**Official Transcript of Proceedings**  
**NUCLEAR REGULATORY COMMISSION**

Title:                   Advisory Committee on Reactor Safeguards  
                                  Plant License Renewal Subcommittee

Date:                    Wednesday, August 18, 2010

7 KEWAUNEE POWER STATION

# Switchyard Layout in 2006

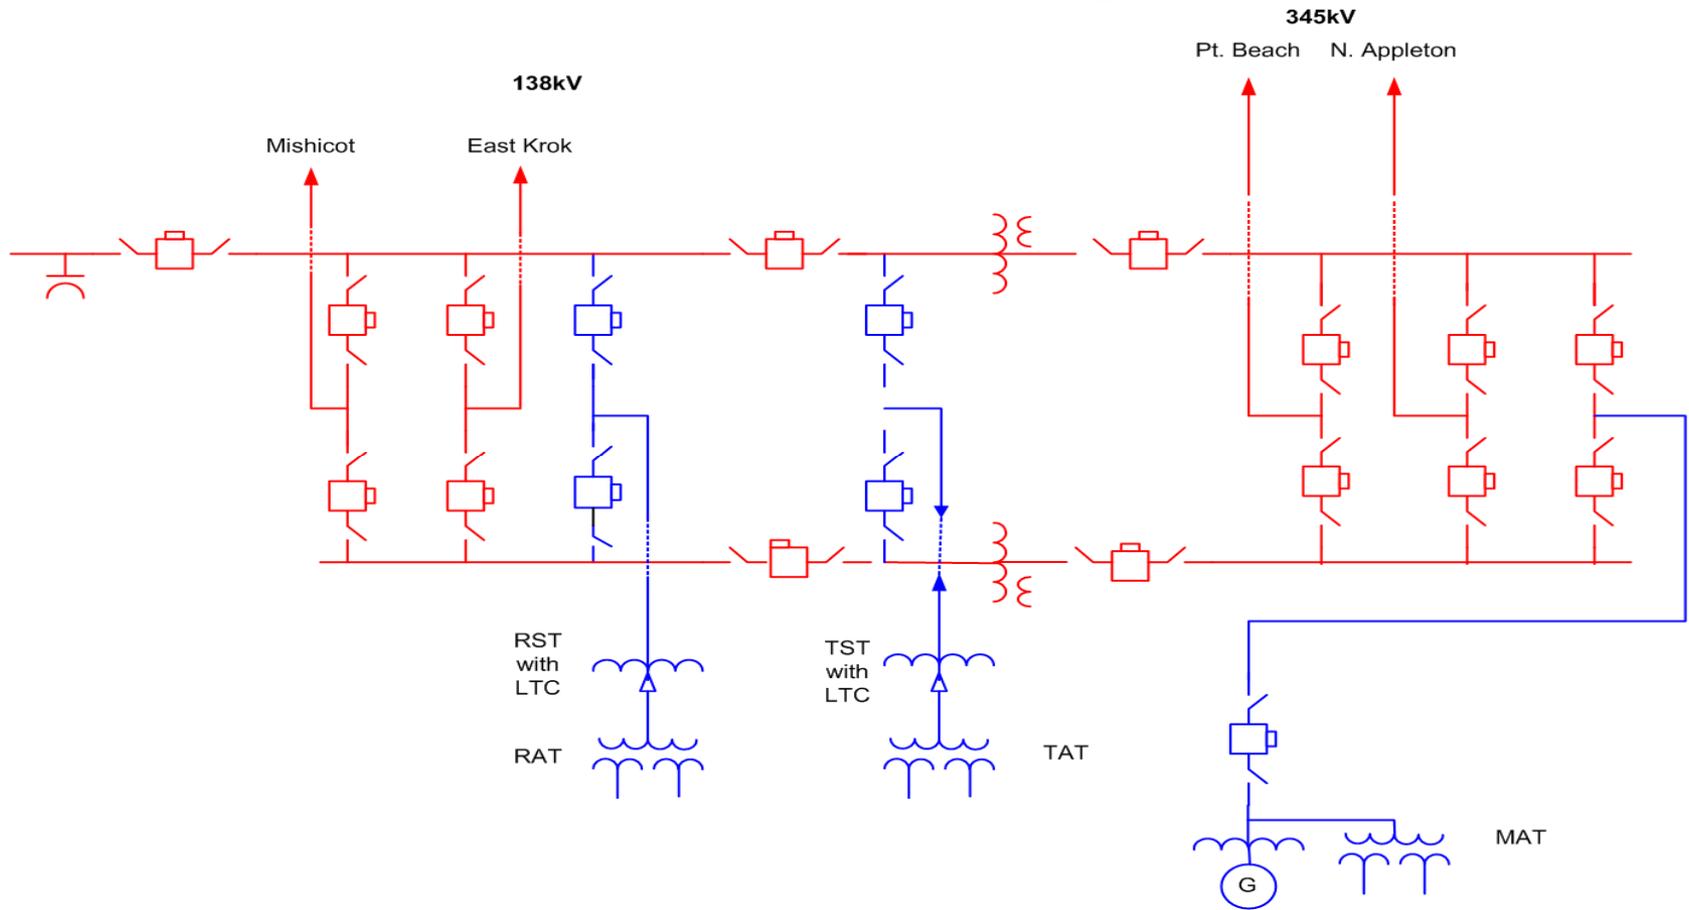
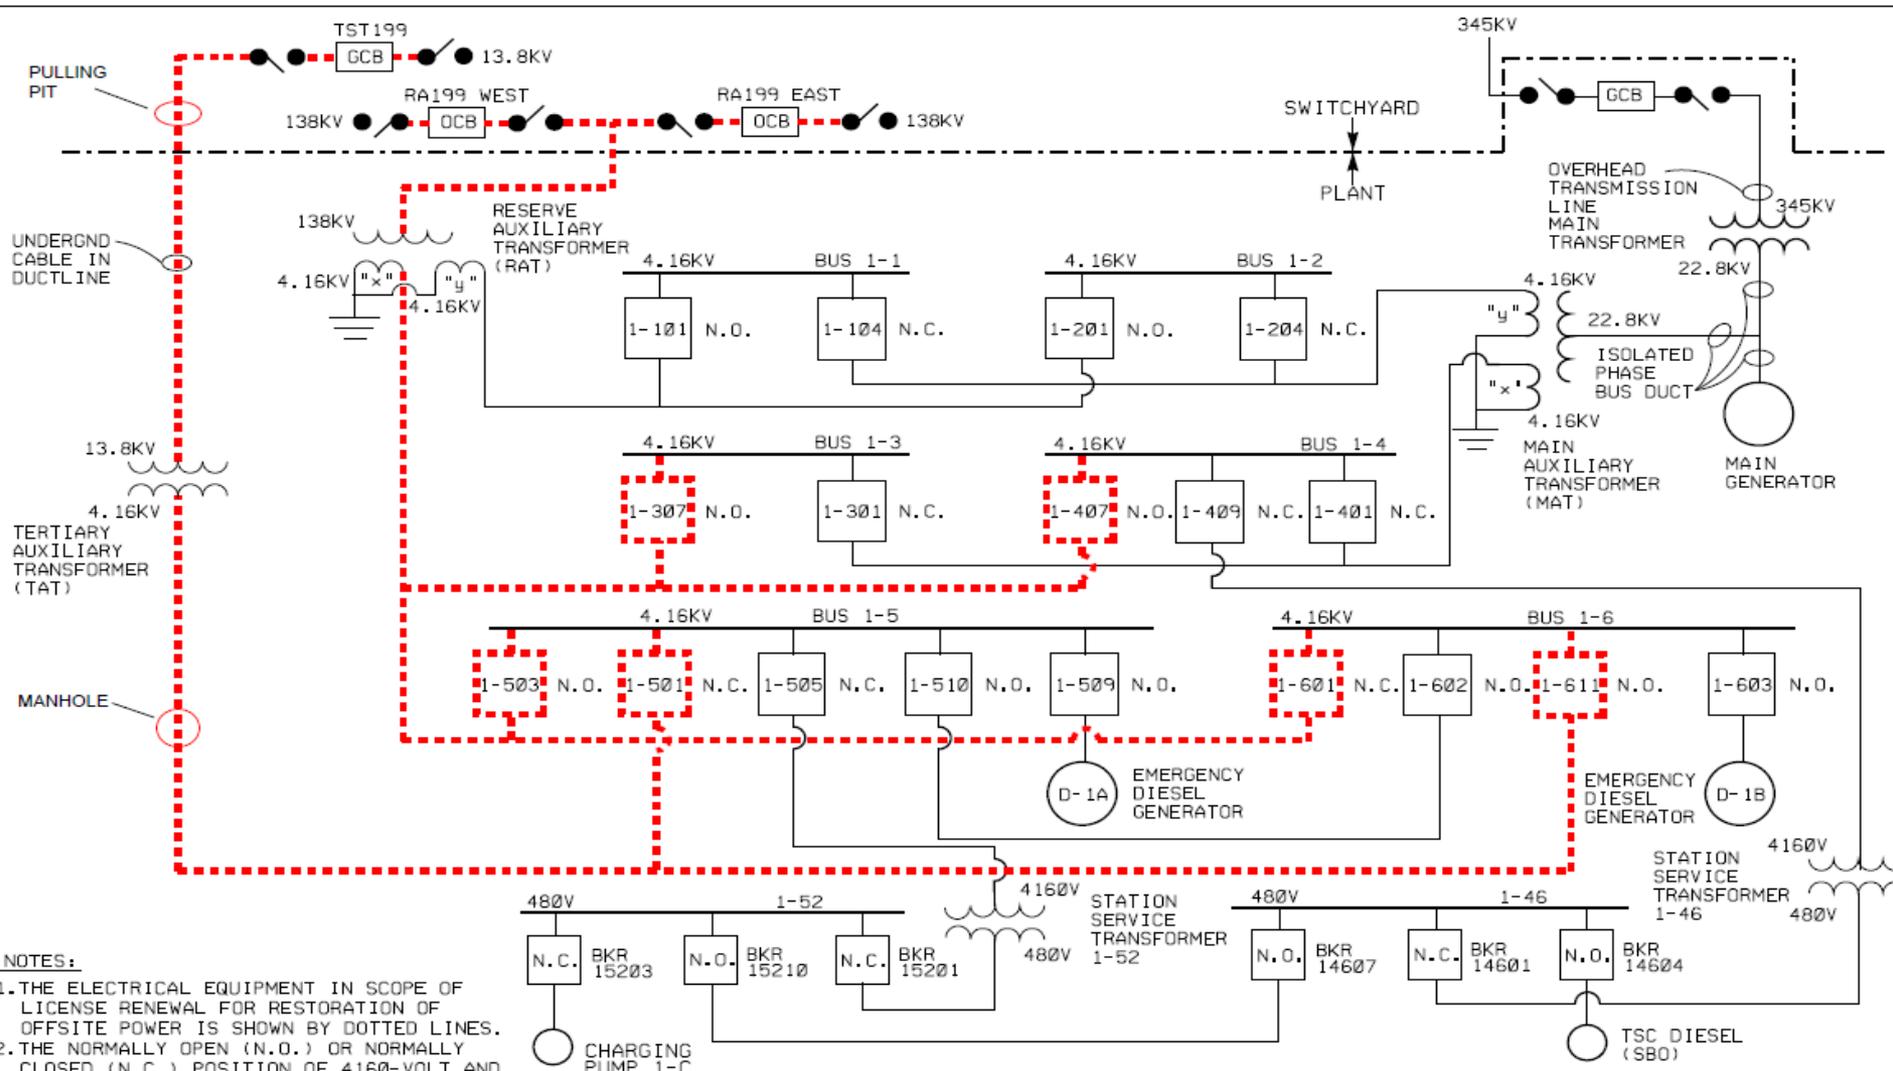
24 MEMBER STETKAR: Stuart, this drawing  
25 you're showing here was not in the license renewal

1 application; is that correct?

4 MEMBER STETKAR: Well, okay, then on this  
5 drawing there is some nice red lines and there are  
6 some nice blue lines. What specific equipment is in  
7 scope for license renewal on this drawing if this is  
8 indeed the configuration that will be in effect at the  
9 time of license renewal?

22 MEMBER STETKAR: Could you go back to the  
23 as-is drawing then?

1                   MEMBER STETKAR:     This is the drawing  
2                   essentially that is in the license renewal  
3                   application. I mean electrically.

2 MR. YUEN: That is correct. This is just  
3 for presentation purposes.

10 MR. AITKEN: We do have another drawing we  
11 can go to.
